## SKORO HOUSE IMPROVEMENTS CONSTRUCTION SERVICES

**ITB #2025-016603**

### **ADDENDUM NO. 1**

ISSUE DATE: October 4, 2024

Model: XG-CC5-1      Cubed Core 1/2"x1/2"x1/2" - Surface Mount  
 XG-CC5-6      Cubed Core 1/2"x1/2"x1/2" - Lay in T-Bar

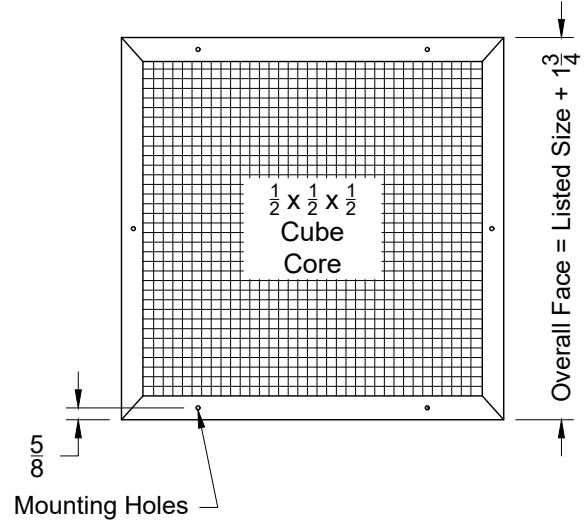
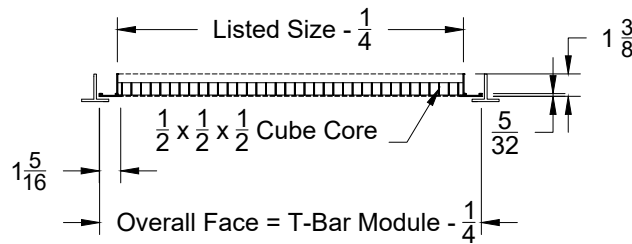
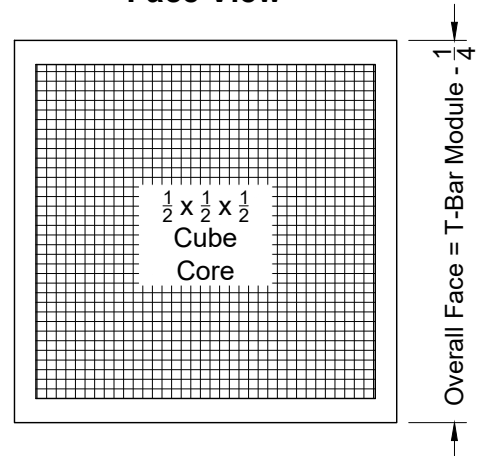
233700      M7.2              N/A              Outlets and inlets for air distribution

PROPOSED SUBSTITUTION: Manufacturer: Greenheck

Accepted               Accepted as noted
